In response to the outstanding Official Final Action dated October 18, 2002 and due for response January 18, 2003, Applicant encloses a Request for a three month extension of time with the fee for a small entity of \$465.00 U.S. funds making this response due **April 18, 2003**. If there is any deficiency or surplusage of the fees enclosed for the Extension of Time (fee), please obtain any such deficiency or credit the surplusage to Deposit Account 08-3255 and advise Applicants' Agent.

IN THE DRAWINGS

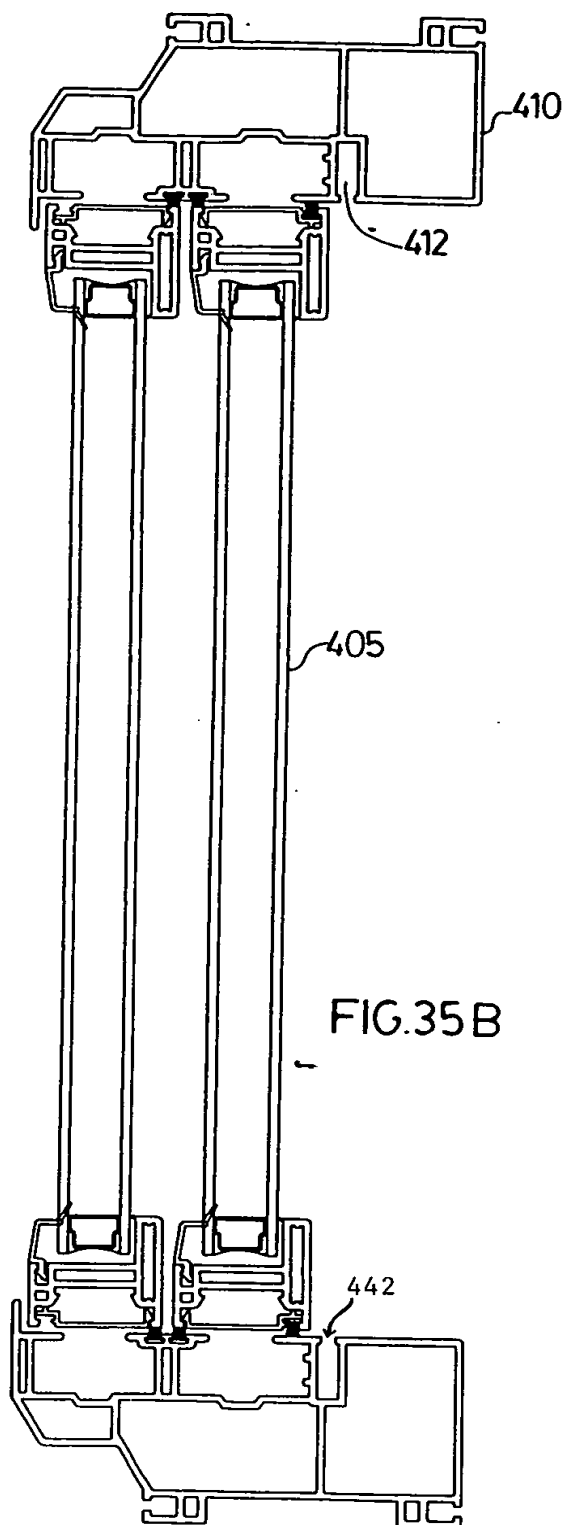
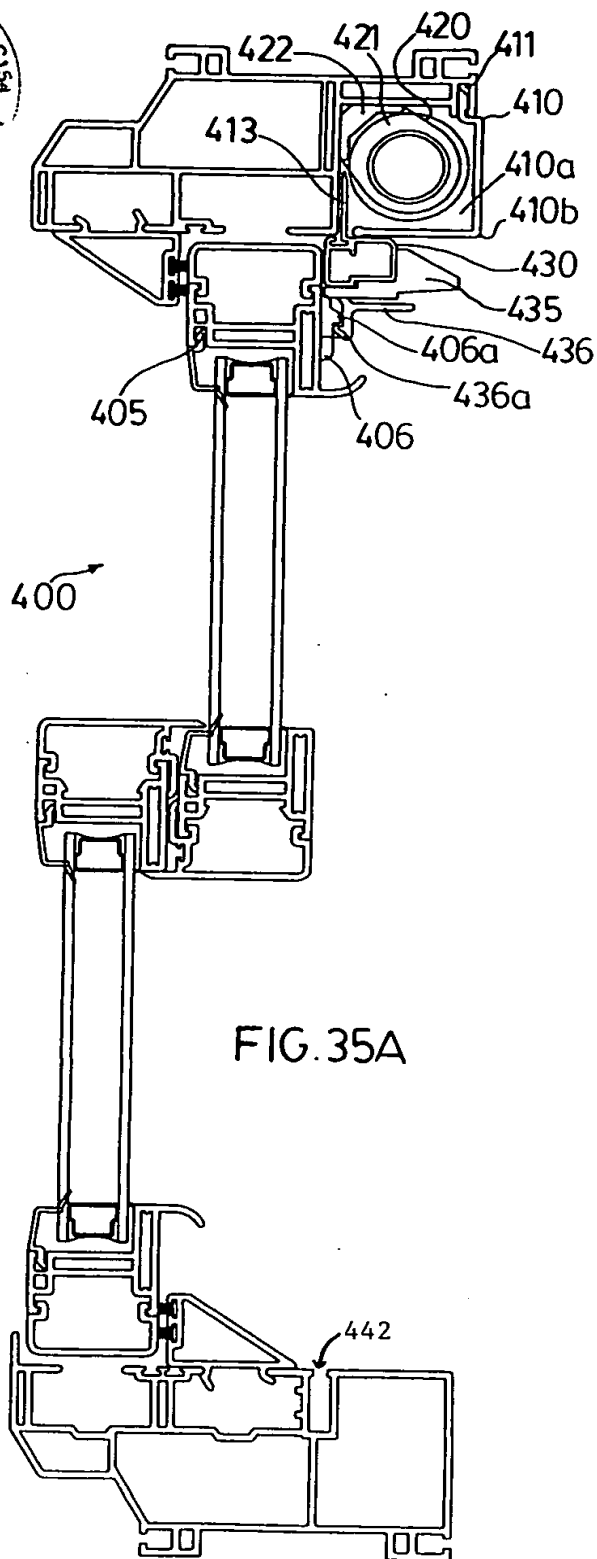
The Examiner has stated that the drawings do not illustrate the features of claims 2 and 10. Applicant respectfully disagrees. Clearly elements 441 and 442 of Figures 35A, 35B, 36 and 38 by way of example (attached) clearly indicate that the guides 412 are providing with the sill and header portions. These may be considered to be guides or grooves as defined in claim 2 and 10. The Examiner is specifically referred to page 45 of the disclosure line 6 onward wherein it states,

"Because of the design of the screen including the telescoping guides as best seen in Figure 36, the screen is guided through channel 412 as best seen in Figure 35B between fully closed and fully opened positions. The glide assembly therefore will accommodate and receive the upper edges and the bottom edges of the generally T-shaped screen portion as best seen and described in relation to Figure 20. An upper glide 441 therefore and a lower glide 442 is provided to ride within the respective channel portions 412 of the jamb framing sections."
